Office Action Summary		Application	on No.	Applicant(s)				
		10/632,30)4	TISOL, JAMES S.				
		Examiner		Art Unit	1 1			
		Amy J. St	erling	3632	MU			
The MAILING DATE of this communication appears on the cover sheet with the correspondence address Period for Reply								
A SHORTENED STATUTORY PERIOD FOR REPLY IS SET TO EXPIRE 3 MONTH(S) FROM THE MAILING DATE OF THIS COMMUNICATION. - Extensions of time may be available under the provisions of 37 CFR 1.136(a). In no event, however, may a reply be timely filed after SIX (6) MONTHS from the mailing date of this communication. - If the period for reply specified above is less than thirty (30) days, a reply within the statutory minimum of thirty (30) days will be considered timely. - If NO period for reply is specified above, the maximum statutory period will apply and will expire SIX (6) MONTHS from the mailing date of this communication. - Failure to reply within the set or extended period for reply will, by statute, cause the application to become ABANDONED (35 U.S.C. § 133). Any reply received by the Office later than three months after the mailing date of this communication, even if timely filed, may reduce any earned patent term

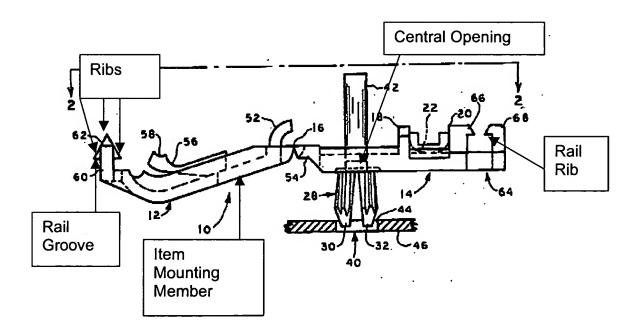
Claims 1-3, 5-9 and 16-20 are rejected under 35 U.S.C. 102(b) as being anticipated by United States Patent No. 4264047 to Nelson.

The patent to Nelson discloses a retainer (10) having a lower mounting base (14) with an upper surface and a mounting base lower surface and defining a central opening (See Drawing Below), the lower mounting base including at least one rail (66) and rib (See Drawing Below) extending outwardly from and across the mounting base upper surface, a release member (68) with a fixed and free end the free end moveable,

the release member extending radially outward from the central opening, and a retainer leg (28) with substrate-engaging surfaces (30) extending outwardly from the mounting base lower surface and an upper component (12) mountable to the lower mounting base, the upper component having an upper surface and a lower surface, the upper component including at least one rail (60) with a rail groove (See marked up Drawing Below) extending outwardly from and across the lower surface of the upper component for engagement with the at least one rail of the lower mounting base, a pair of side ribs which are parallel to a central rib (62) extending outwardly from and across the lower surface of the upper component for engagement with the release member, and an itemmounting member (See Drawing Below) extending outwardly from the upper surface of the upper component for mounting items to the retainer and a leg finger (42) which extends through the central opening to facilitate insertion and removal of the lower mounting base in the substrate.

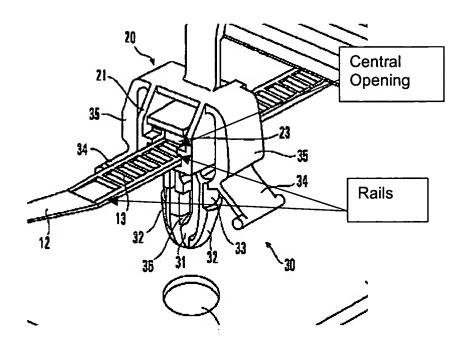
Claims 1 and 4 are rejected under 35 U.S.C. 102(b) as being anticipated by United States Patent No. 6749157 to Takeuchi.

The patent to Takeuchi discloses a retainer (1) for use in securing items within a vehicle having a lower mounting base (20) having a mounting base (35) upper surface and a mounting base lower surface and defining a central opening (See Drawing Below), the lower mounting base including at least one rail (See Drawing Below) extending outwardly from and across the mounting base upper surface, a release member (23) extending radially outward from the central opening, and a retainer leg (31) extending outwardly from the mounting base lower surface and an upper component (10) mountable to the lower mounting base, the upper component having an upper surface and a lower surface, the upper component including at least one rail (See Drawing Below) extending outwardly from and across the lower surface of the upper component for engagement with the at least one rail of the lower mounting base, a central rib (13) extending outwardly from and across the lower surface of the upper component for engagement with the release member, and a ring shaped item-mounting member (10) extending outwardly from the upper surface of the upper component for mounting items to the retainer.

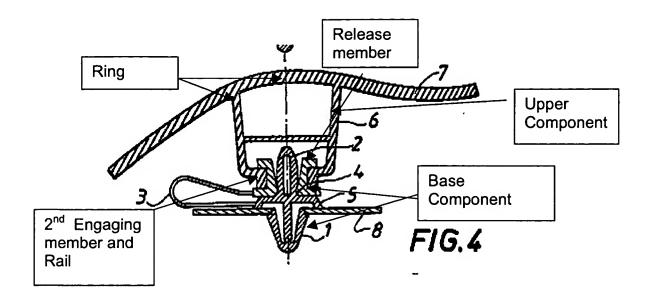
Claims 10-15 are rejected under 35 U.S.C. 102(b) as being anticipated by United States Patent No. 6394695 to Chausset.

The patent to Chausset teaches a base component (See Drawing Below) including a first component engaging member (4) a retainer leg (1) with a substrate engaging member (11) extending outwardly from the base component, and a release member with a movable free end (See Drawing Below) and an upper component including a ring (See Drawing Below), a second engaging member (See Drawing Below), including a rail and a leg finger (2) which extends through the central opening in the base
